**RE: APPROVAL WITH MODIFICATIONS
FRENCH DRAIN SOIL SAMPLING INVESTIGATION WORK PLAN
WESTERN REFINING SOUTHWEST INC., GALLUP REFINERY
EPA ID # NMD000333211
HWB-WRG-20-022**

The New Mexico Environment Department (NMED) has reviewed the *French Drain Soil Sampling Investigation Work Plan* (Work Plan), dated December 15, 2020, submitted on behalf of Marathon Petroleum Company dba Western Refining Southwest Inc., Gallup Refinery (the Permittee). NMED hereby issues this Approval with Modifications with the following comments.

■ Suggested Additional Boring Locations

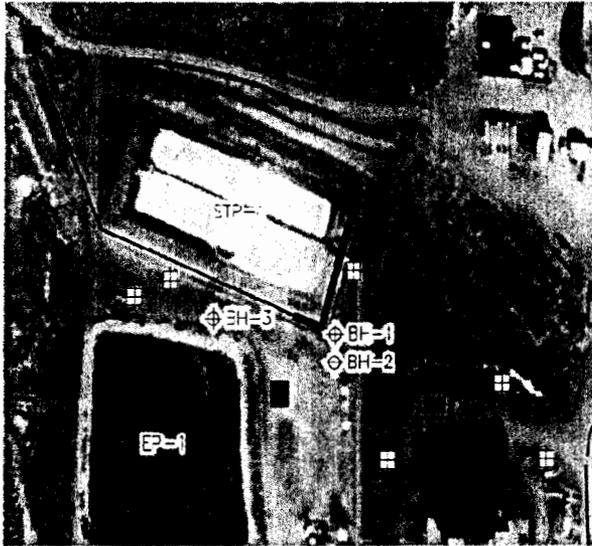
In the Investigation Methods Section, page 7, the Permittee states, “[t]he proposed sampling locations are shown on Figure 3. The proposed locations include six boreholes around the STP-1 French Drain area.” The proposed sampling locations shown on Figure 3 are anticipated to delineate the extent of hydrocarbon contamination detected at BH-1, BH-2, and Excavation #9; however, do not appear adequate to delineate the extent of hydrocarbon contamination detected at BH-3 and potential hydrocarbon contamination northwest of the French Drain. Two additional soil borings as shown in the figure below must be proposed in the revised Work Plan. The suggested boring locations below may be adjusted based on the accessibility of the site. Revise the figure accordingly.
